**STRICK TRAILERS, LLC**

**IMPORTANT SAFETY RECALL**

**This notice applies to your vehicles identified on the enclosed spreadsheet**  
**NHTSA Recall No. 16V-212**

Strick Trailers, LLC (“Strick Trailers”) has decided that certain dry freight van trailers, model number S4280E99NFOWW, identified on the enclosed spreadsheet, fail to conform to Federal Motor Vehicle Safety Standard No. 223 “Rear Impact Guards”.

MATERIAL: X		STRICK	STRICK TRAILERS, LLC	MONROE IN 46172	SW
FIELD INST. RIG. ESTES, 52236/37 FIX. 0068		GUSSETS 52236/52237			
PART NUMBER		706545			
SHEET NUMBER		Sheet 2 of 2

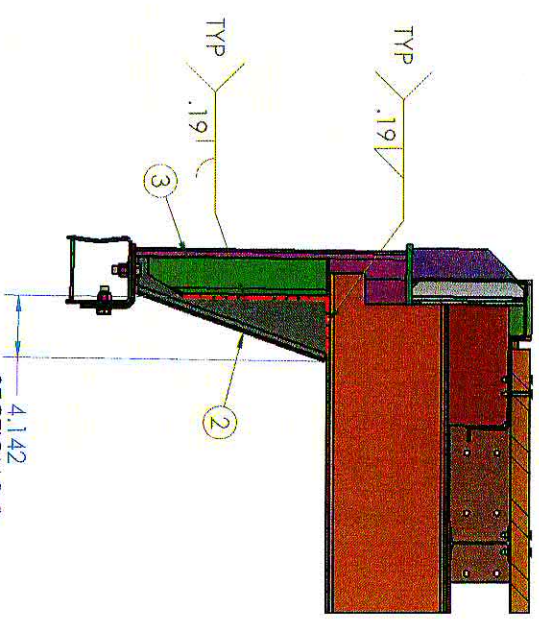
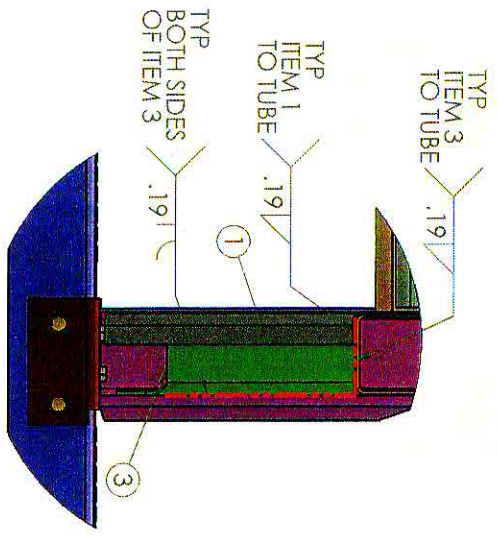
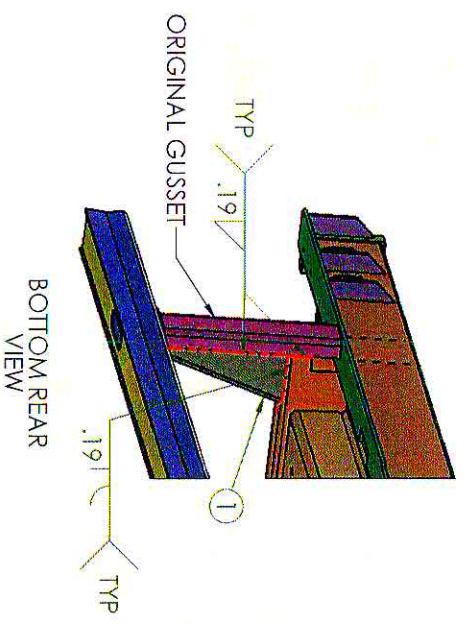
The noncompliance is in regards to the curbside and roadside rear impact guard gussets. Strick Trailers identifies the gussets with the numbers 52236 and 52237. These gussets do not meet the requirements of Federal Motor Vehicle Safety Standard 223 pertaining to rear impact guards. This could increase the risk of injury in the event of a rear impact crash.

In order to remedy the noncompliance, it will be necessary to reinforce the curbside and roadside rear impact guard gussets in accordance with the instructions (Drawing 706545) attached to this letter. We will supply the new reinforcement parts without cost and will ship them to multiple locations at your request. We will also reimburse you for the reasonable direct labor costs involved in effecting the repair or will have the repair facilities bill us directly. The work to reinforce the rear impact guard gussets will take approximately two and one half hours to perform.
